From: Joyce Christie
Sent: 10 April 2025 19:07
To: Nathanael Stock; Shona King
Cc: Enforcement Planning; DC Support
Subject: RE: 25/00527/DISC - Condition 9 of 24/01880/LB North Arms

P11D shows the whole floor plan. Drawings 12C and 13B were also submitted but these are not relevant to Condition 9 of 24/01880/LB.

Extract P11D

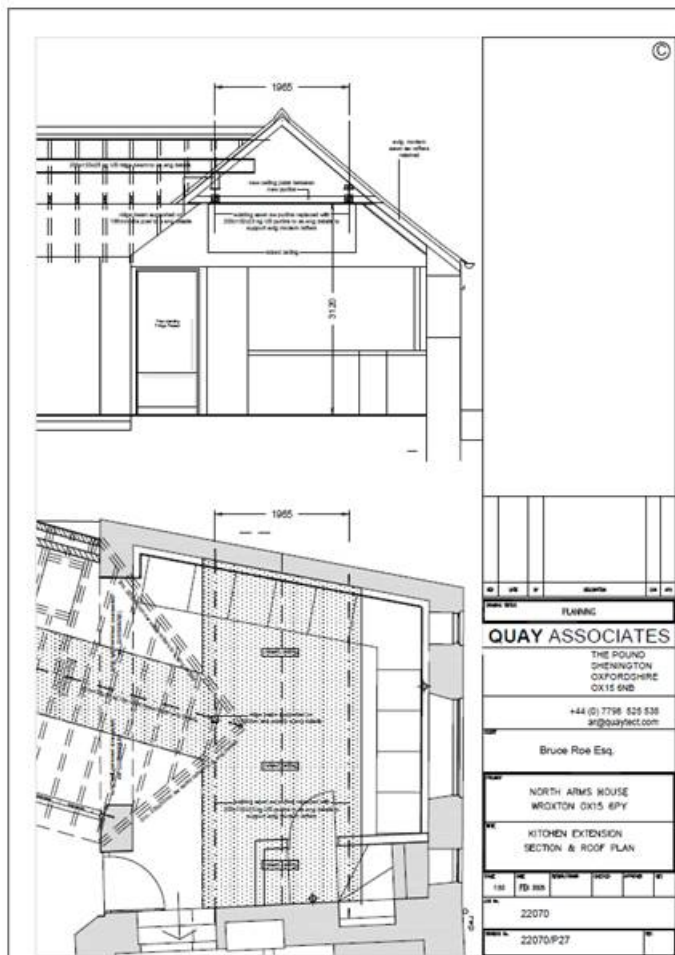
Please ask for a bit more information on Drg P27 to show the existing floor slab junction with the new floor slab and how the ceiling finishes between the existing and proposed relate to one another. Please also confirm how the new steel that is to be inserted to support the ridge of the new roof will be embedded in the masonry. Can they supply further detail on the junction between the extension roof and the stone pier between the large opening and the door. Please note Drg P11D and P27 are different as P11 doesn't show a door and appears to show a wider opening?
